ADDENDUM No. 1

TO: Planholders of Reclamation District No. 1000, 2024 Gravel Roadway Project

SUBJECT: Revisions to Bid Package for Reclamation District No. 1000, 2024 Gravel Roadway Project, Specification No. 1000-05-24-2

EXHIBIT 3

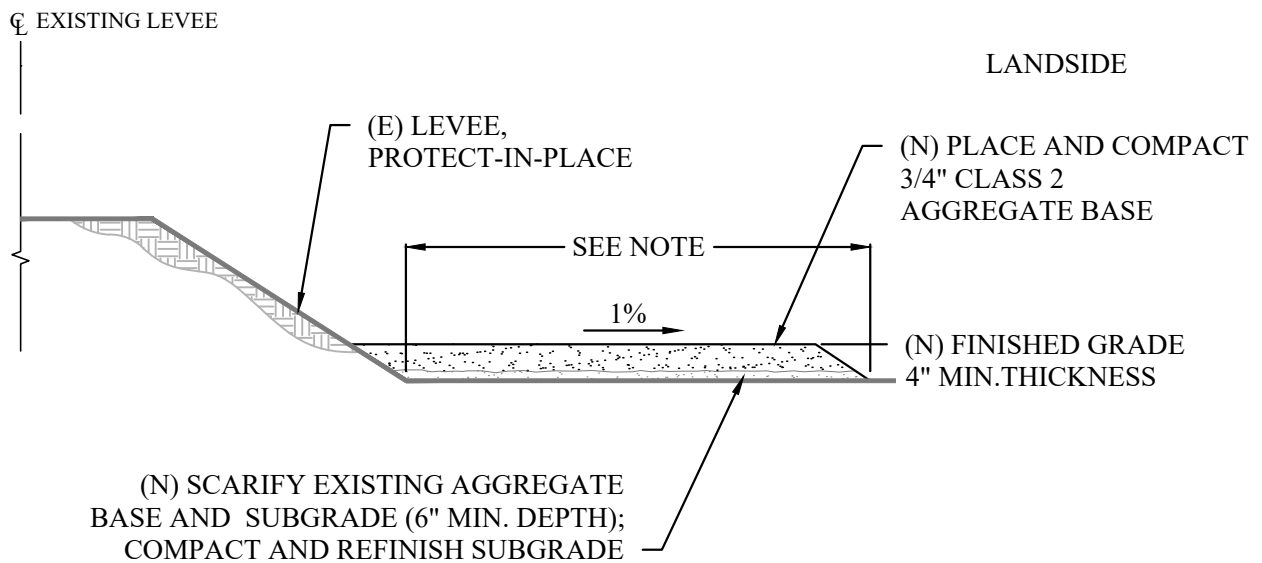
1. Exhibit 3 of the plan set is revised to clarify the subgrade preparation before placement of new aggregate base. Existing aggregate shall remain in place.
